**Re: Draft Permit No. 1070014-001-AV
Heat Input Information for Oil Firing
FPL Putnam Plant Initial Title V Permit**

**RE: FLORIDA POWER AND LIGHT COMPANY
PUTNAM POWER PLANT
TITLE V AIR OPERATION PERMIT
DRAFT PERMIT NO: 1070014-001-AV**

Re: Draft Permit No. 1070014-001-AV
FPL Putnam Plant Initial Title V Permit

Re: Request for Additional Information Regarding Initial Title V Permit Application
File No. 1070014-001-AV
Putnam Plant, Putnam County

Putnam Plant Unit 1 or 2
Heat Input Variation With Ambient Temperature (Oil)
Each Combustion Turbine (with / without duct burners)

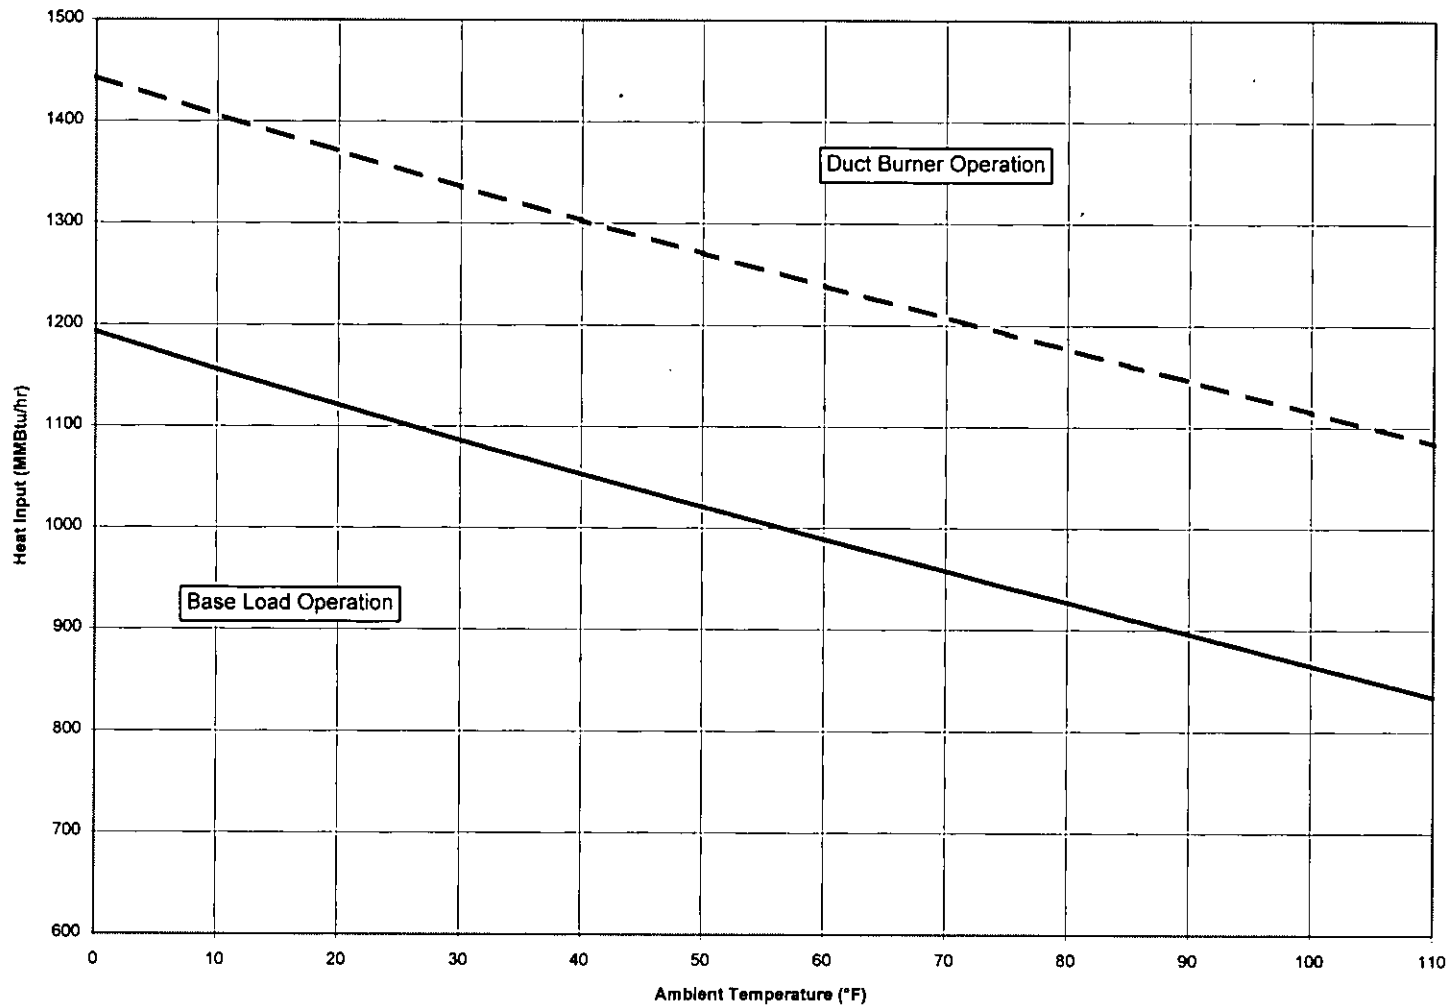
Attached for your use please find a graph of the ambient temperature vs. heat input data for the Putnam plant combustion turbine units for distillate oil firing.

**Putnam Plant Unit 1 or 2
Heat Input Variation With Ambient Temperature
Each Combustion Turbine (with / without duct burners)**

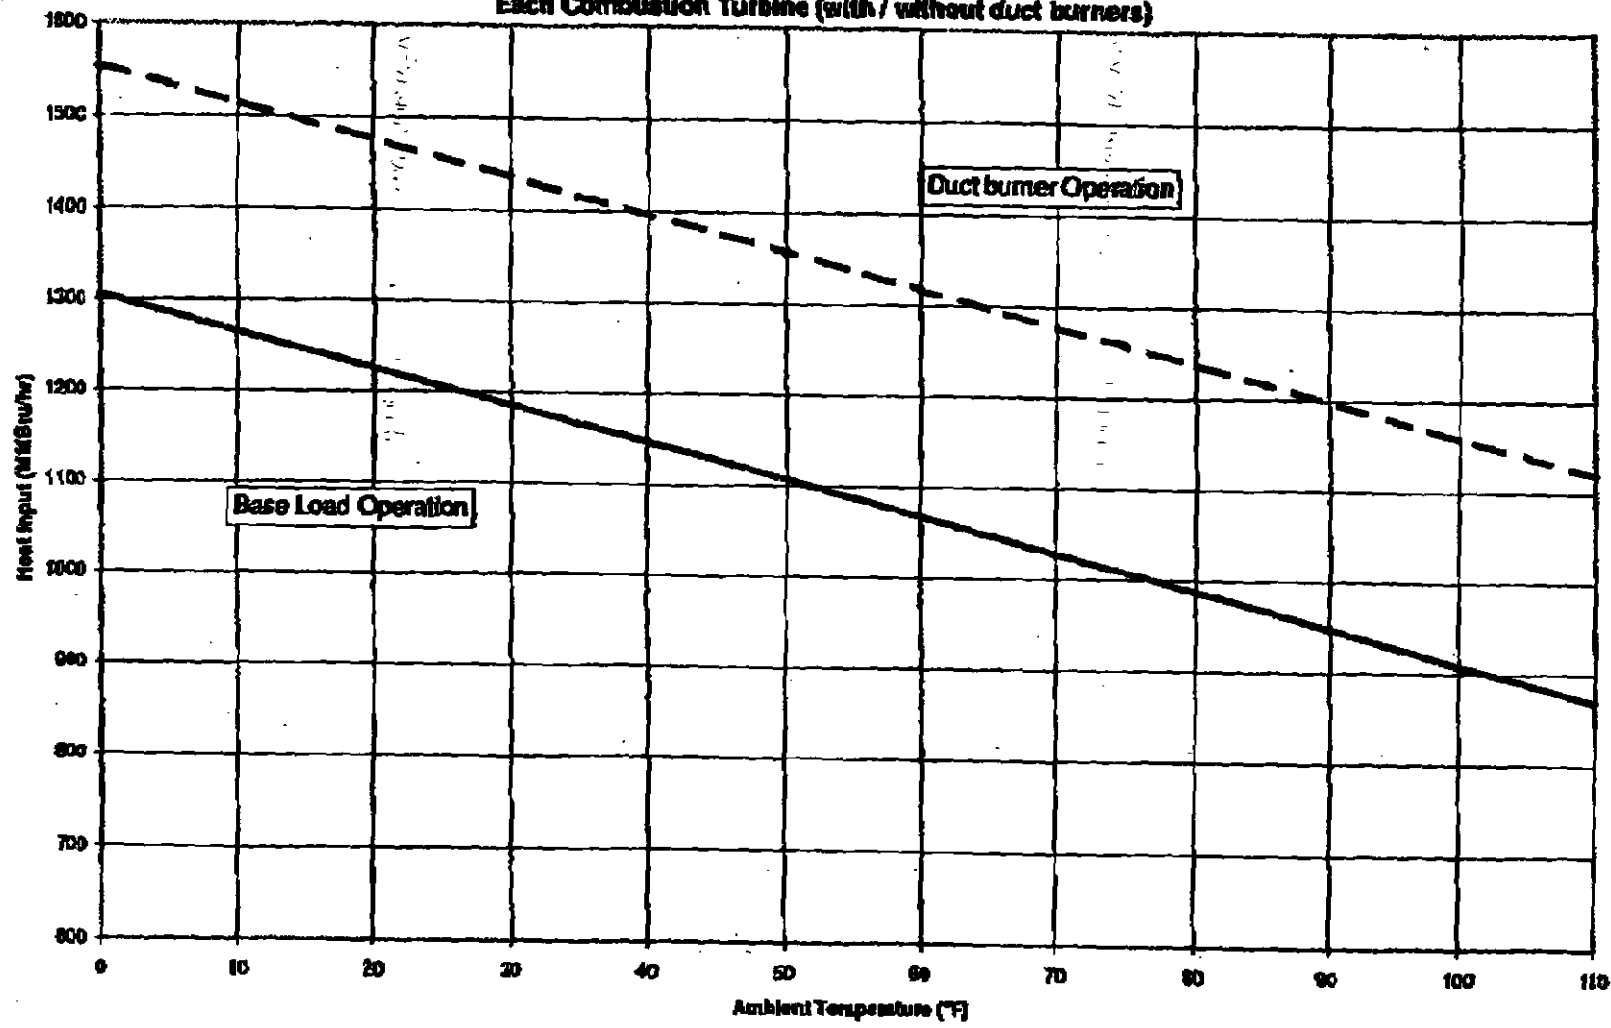
Putnam Plant heat input → the number to use as a
reference in the various places in the permit is 1265
mmBTU's at 10°F.
